Council Internal Referrals

To: Hannah Painter
From: Preetha Kumar
DA No: SSDA
Subject: 92-116 Gow Street, Padstow
Date: 9 October 2023

To: Hannah Painter, Strategic Planner
From: Rui Liu, Urban Designer
File Ref: SSD-52861709
Address: 92-116 Gow Street, Padstow
Date: 23 October 2023

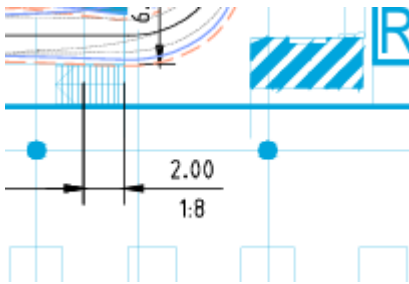
- b) Location of pedestrian access between two heavy vehicular access is not a safe location. Consider relocating pedestrian access towards the western boundary.

3. Vehicular Access

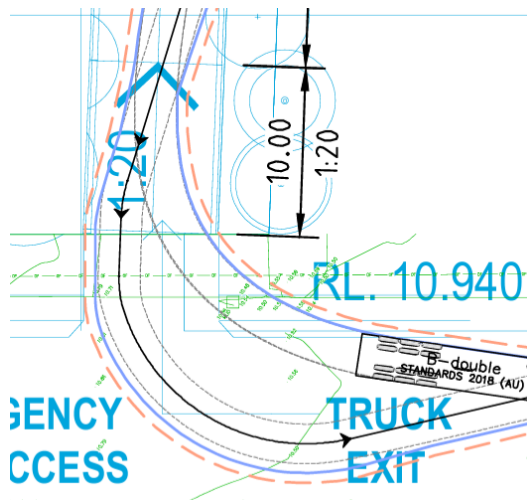
- All VFCs are to be dimensioned.
 - The extent of the carriageway needs to be shown while presenting turning paths
 - Assume on-street parking is occupied on both sides of Gow Street
 - The existing VFCs on the opposite side and adjoining properties are to be shown
 - To minimise damage on to the kerb and gutter the 600mm clearance needs to be clear
 - A shared access between trucks and cars is not acceptable. Separate VFCs are to be provided.
- a) Eastern most VFC
- The VFC will need to be widened to minimise impact on kerb and gutter and loss of on-street parking.

b) Truck entry and exit to/from Warehouse 4 VFC

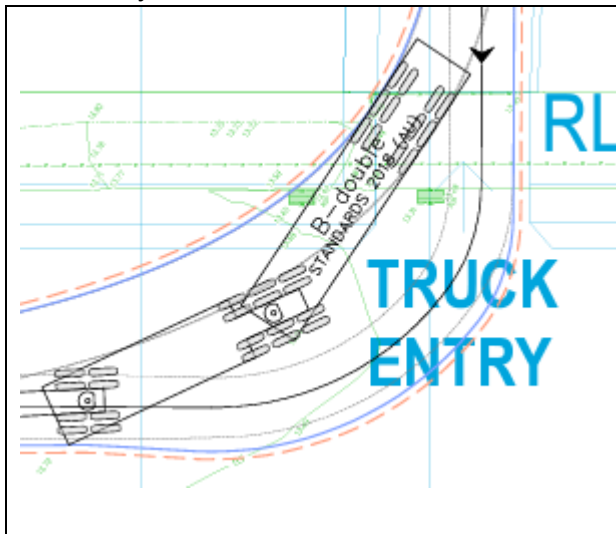
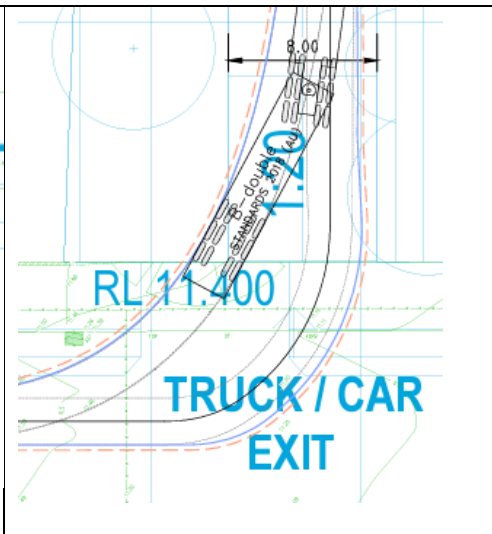
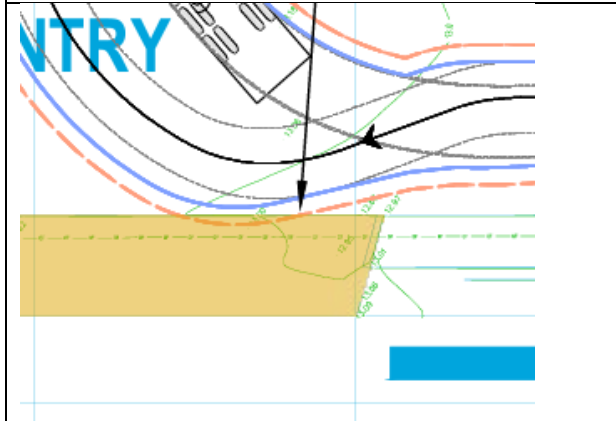
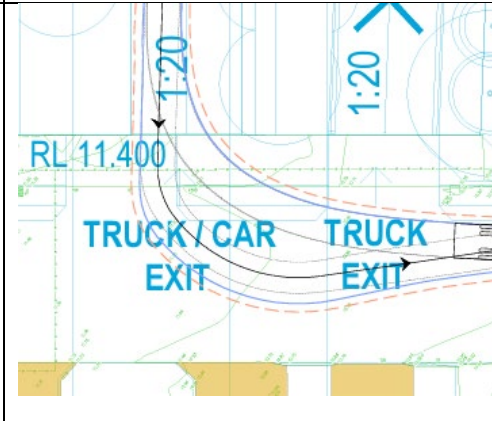
<p>Too tight and needs to be widened</p>	<p>Shared access not acceptable</p>

On-street parking is affected. Not acceptable. Driveway is to be either widened or smaller truck to be considered.

Assume on-street parking is occupied. Shared access not acceptable.

c) Western most Exit Driveway

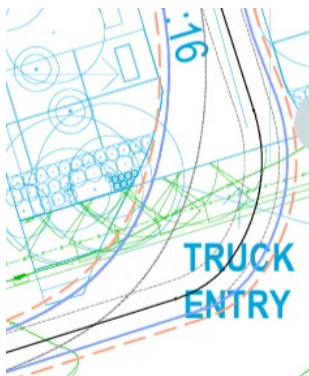
VFC needs to be clearly shown on the drawing in order to assess and comment on turning path

a) Heavy vehicles

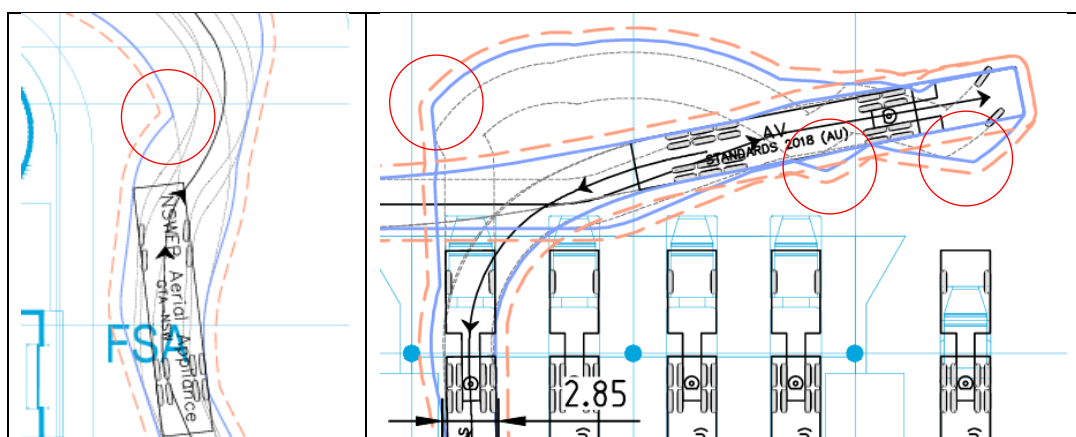
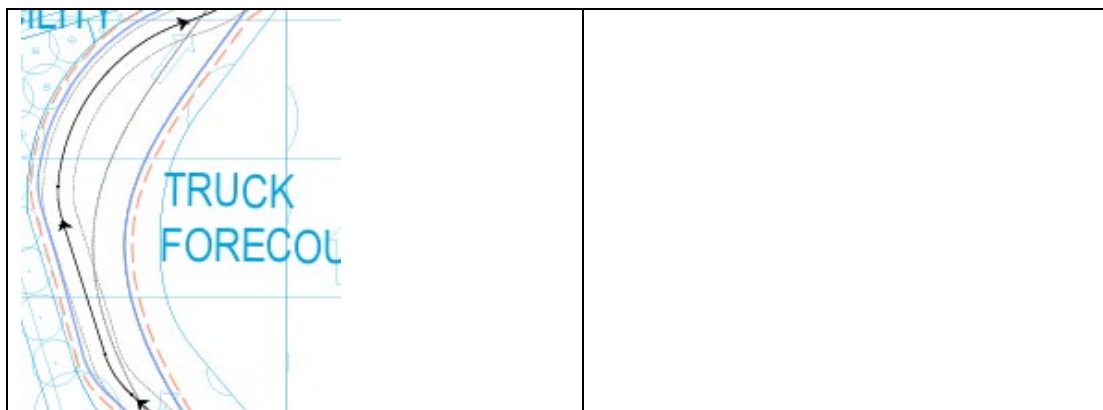
The vehicle swept paths indicate that the 'turn wheel from stop' was used, which requires the vehicle to stop and turn its wheels before proceeding, which is not a realistic driver's behaviour and could often have an impact on traffic flow efficiency or cause congestion or even a rear end collision in some situations. Please ensure that the turning paths provided are smooth and the "turn wheel from stop" is not switched on. See screenshots below. This turning paths is not acceptable.

b) Heavy vehicles

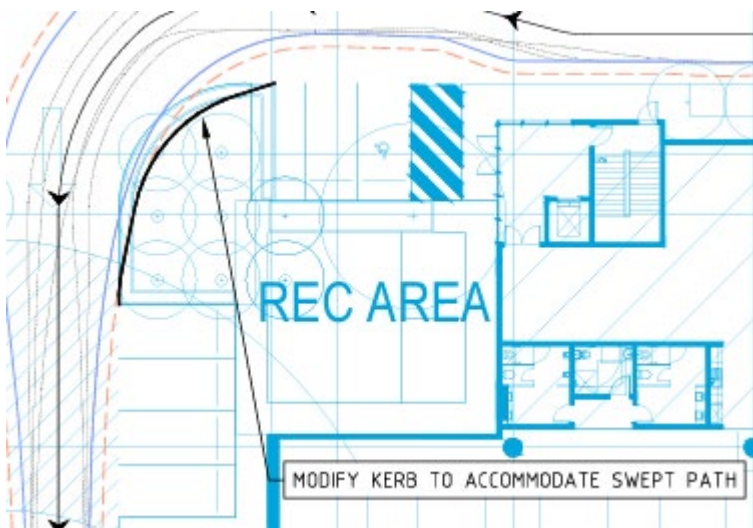
Too tight

Modified kerb to be shown on the revised drawing that will be next sent to Council.

c) Normal cars

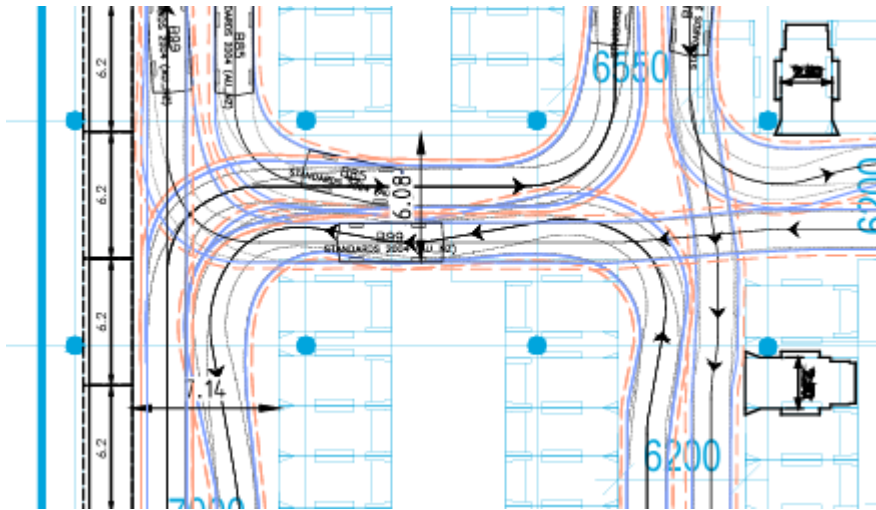
For these turning paths to be assessed they need to be clear, legible and shown in separate drawing. The below is not acceptable.

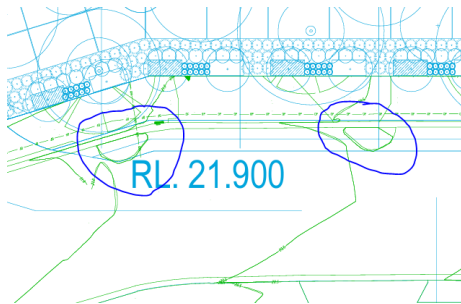
Existing power pole in the way of the VFC. The Applicant is to fund the relocation of the power pole.

Traffic islands that will not be required are to be removed at the Applicant's cost.
